1999 SOCCER FIELD AND TRACK ADDITIONS TO ROCKWALL HIGH SCHOOL
ROCKWALL INDEPENDENT SCHOOL DISTRICT
ROCKWALL, TEXAS

DATE 31 AUG 1999
DRAWN BY KKE
CHECKED RAH
COMM NO 1-97-113
REVISED

TRACK DETAILS
AS SHOWN

SHEET NUMBER C 2.9
OF 20
SET NUMBER

TRACK PAVEMENT DETAIL
NTS

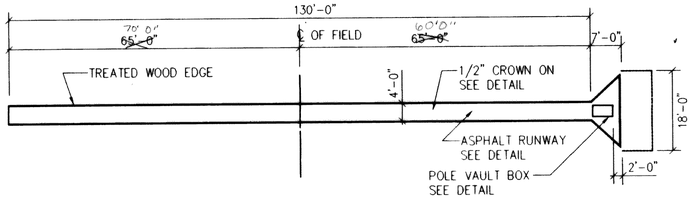
Note: The 8" subgrade, 4" base course asphalt and 2" wearing course asphalt is correct. Any mention in the specifications of subgrade to base is different thickness than these shown are incorrect. Additionally the tracks is to be latex as specified.
